Project : Renos & Additions to Northern
Address: Lebanon Middle & High School

Change Order No: 27
Date: 8/2/2024
Architect's Project No: 3624

To provide Door Access and Hardware revisions associated with ASI-17. This change order is for the installation of cables and devices portion of ASI-17. See the attached McCarty revised COR EC-61RC (8733RC) dated July 31, 2024. Also included as back up documentation is the original ASI-17 cover page identifying all doors included as part of this ASI, CRA's 7-17-24 email showing reduction in the number of doors to be excluded, the original McCarty COR EC-61 and 61R which have since been revised.

ARCHITECT'S SUPPLEMENTAL INFORMATION – ASI #17

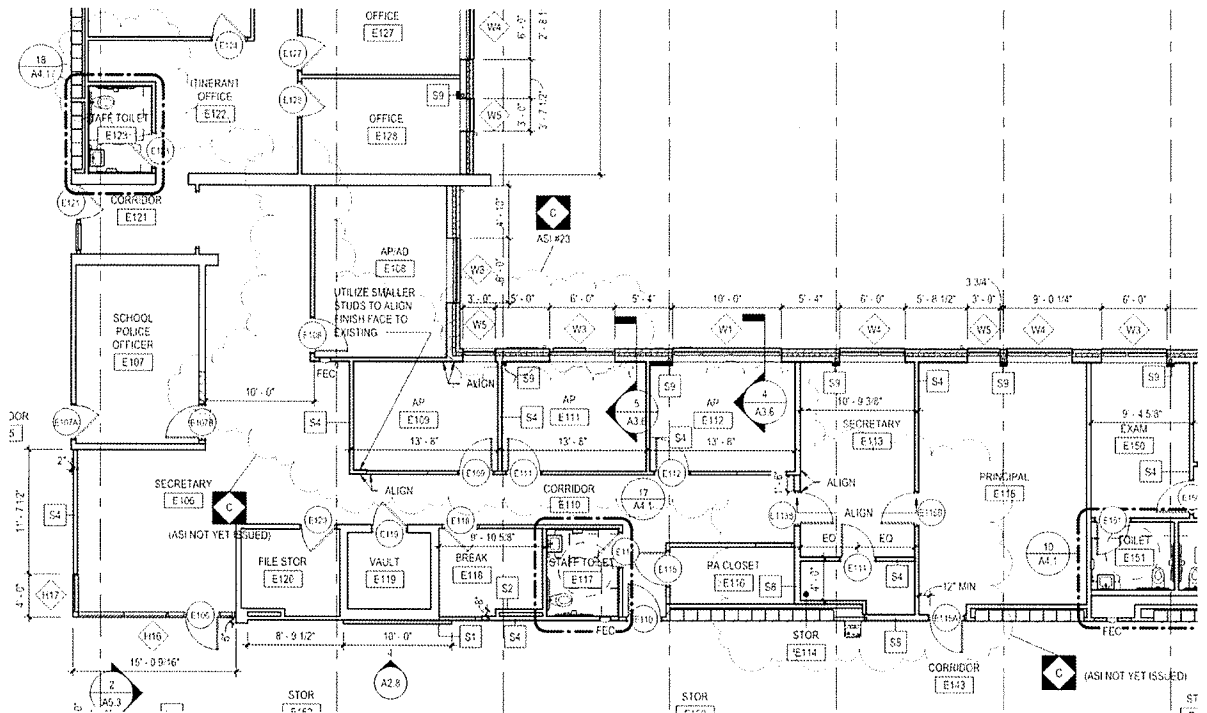
- This ASI contains revisions to door access and door hardware.
- There are also updates to the door schedule to capture mark-ups in returned door/frame shop drawings.
- As a note, the revisions also include doors and frames related to a forthcoming separate ASI. Please include the doors and frames in this ASI, to expedite the door/frame procurement. For context, below is a snip of the forthcoming layout adjustment in a future ASI:
